REV. 14
 BUILDING: REACTOR
 ISO. NO.: MCFI-INI38
 DUKE PIPING CLASS: ASME SECT III CLASS A
 SYSTEM SYMBOL: NI SAFETY INU SYST
 PIPING SPEC: NI-43 PS-2501.1
 DRAWING NO.: MC-1414-09.20-C7-08
 PROJECT: MCGUIRE
 QA CONDITION I
 INSERVICE INSPECTION

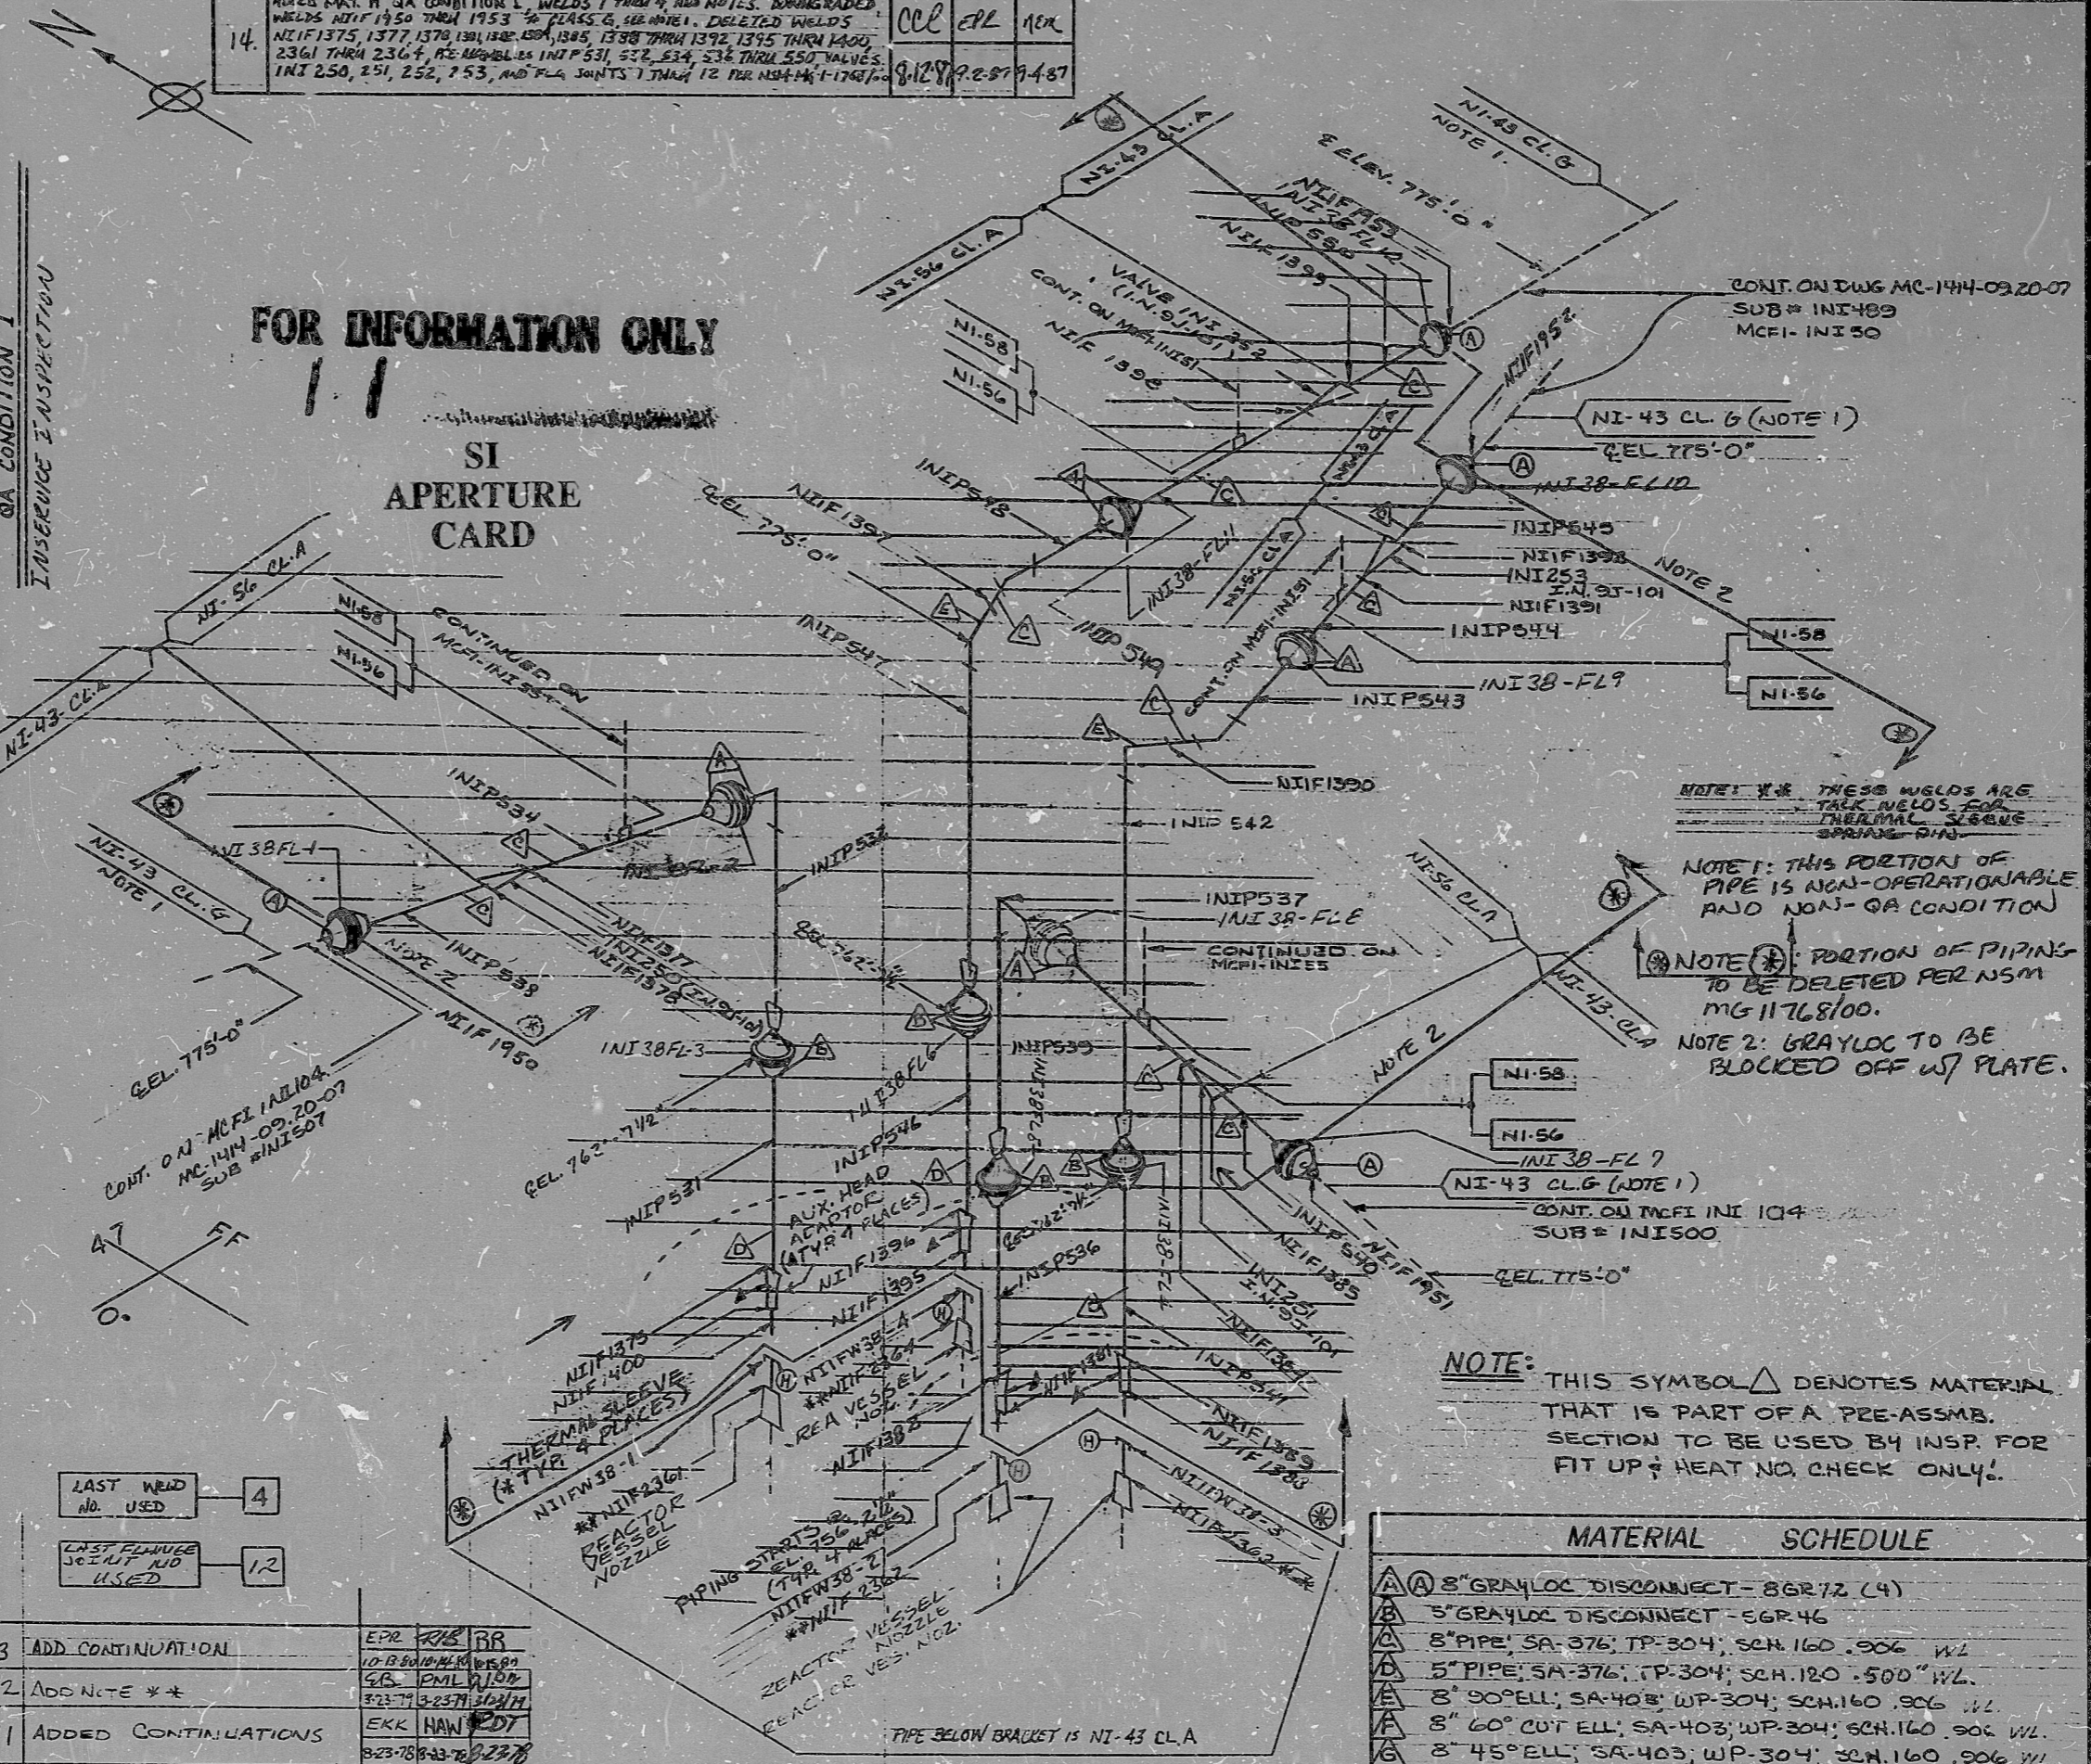
ADD WELDS NIIF 2301, 2302, 2303, 2304. REVISED TO EL. 762'-7/2" AT 5" GRAYLOCK'S (VN 11408)
